**Subject:** RE: Comment Request on Coal Ash Site Assessment Round 12 Draft Reports

**RE: Former Ash Pond at Plant Crist**

Re: Gulf Power Company  
Crist Electric Generating Plant  
NPDES Permit No. FL0002275  
Pond Ash Removal

**RE: Plant Crist Former Ash Pond NPDES Permit No. FL0002275**

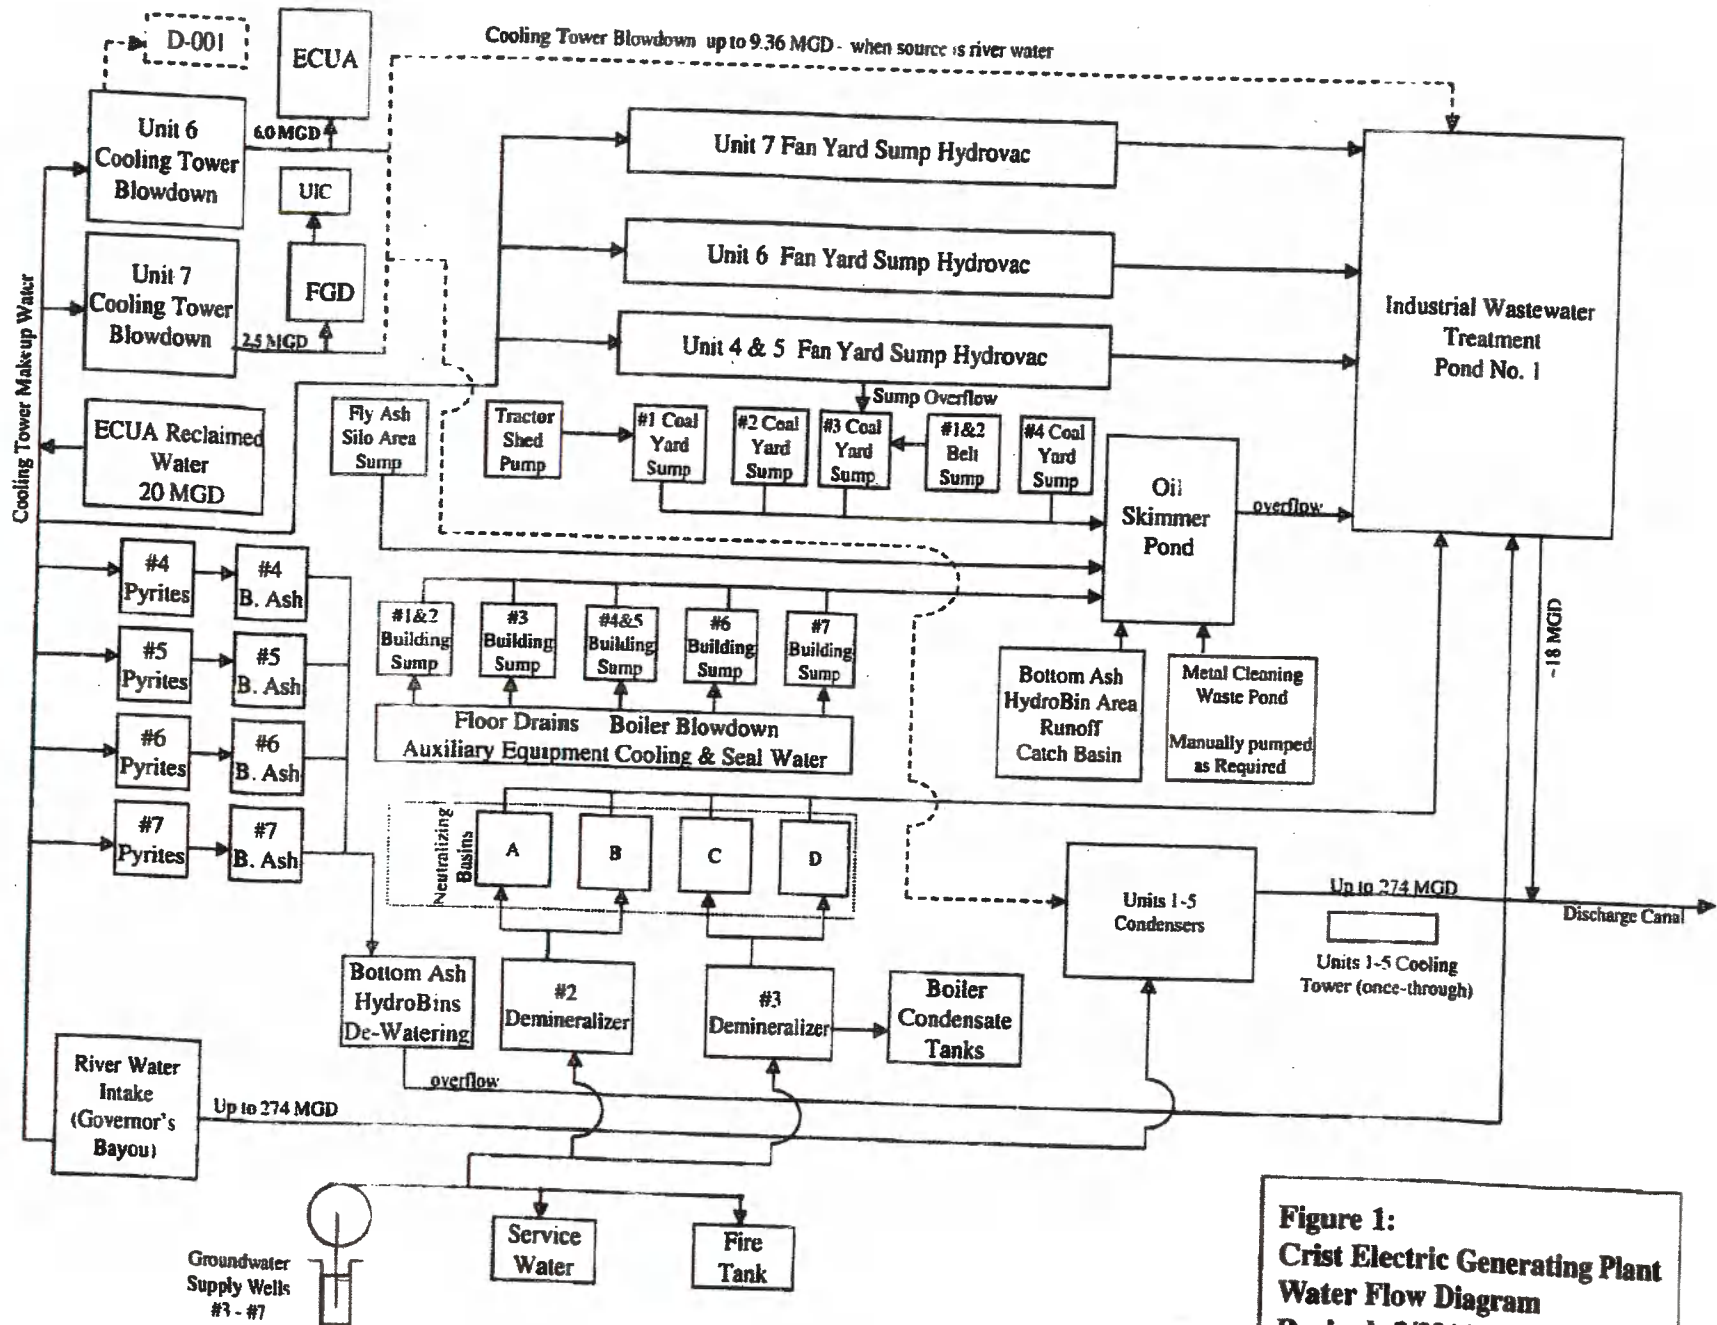
The former ash pond is no longer used for the active storage and treatment of ash and therefore should be removed from the Department's database of ash ponds. To identify the conditions onsite, attached Figure 1 illustrates current operations at Plant Crist, along with renaming the former Ash Pond as "Industrial Wastewater Treatment Pond No. 1."

The Florida Department of Environmental Protection (Department) acknowledges receipt of Gulf Power's letter dated March 24, 2014, regarding the removal of historical ash from the ash pond at Plant Crist. The Department recognizes that with the cessation of coal ash storage and treatment in the pond the term "ash pond" would no longer be appropriate. Please notify both the Department's Industrial Wastewater Program and the Northwest District Office upon completing the removal of the historical ash from the pond.

The pond description in the above referenced NPDES permit will be updated to reflect the use of the pond during the following permit revision or renewal, whichever occurs first. Please note that the monitoring requirements for the pond remain in effect.
